# MINOR PROJECT REFINEMENT REQUEST FORM

**Request Number:** 06  
**Date Requested:** September 23, 2022  
**Proposed Duration/  
Timing of Use:** Upon approval through October 31st, 2022  
Daytime hours  
**Location:** Access route and work area at Pole 56  
APN: 018-261-008-000  
**Attached Map?**  Yes  No

**Client/Project** 185705825  
 PG&E Humboldt Bay-Humboldt #1 60kV  
 Minor Project Refinement 06

**Title**  
**Pole 56 - Overland Access and Work Area**

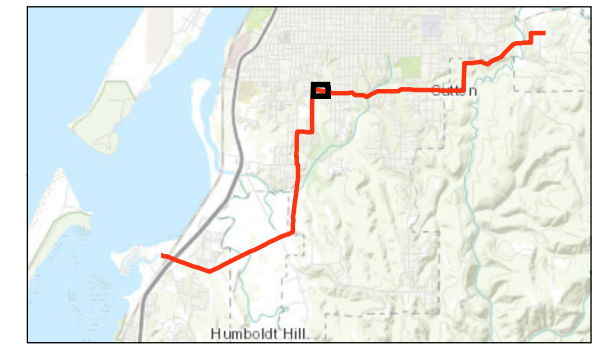
PG&E proposes to utilize an overland access route and expand the Pole 56 work area from 20 ft. x 20 ft. to approximately 75 ft. x 75 ft. The pole is located in a wetland adjacent to a private residential driveway in the City of Eureka (APN: 018-261-008-000). The proposed access route and work area are located within the study area of the Final IS/MND.

The access route would utilize an existing overland route that extends approximately 275 feet from the end of a paved driveway. The route was established by the landowner and crosses through seasonally flooded wetland habitat. The route spans an inundated finger of Martin Slough via a culverted crossing. The overland route would be used by a tracked excavator and rubber-tracked bucket truck required for pole excavation, culvert sleeve installation, and installation the new pole. Because the pole would be installed with ground-based line equipment instead of a helicopter, the work area would need to be expanded to accommodate ground-based equipment.

The proposed pole work area and access route are within areas previously surveyed for jurisdictional waters. Both the access route and pole work area are within seasonally flooded forested and scrub-shrub wetlands. The access route crosses a culverted channel of Martin Slough (approximately 10 ft in width). Mapped jurisdictional waters are shown on Figure 1.
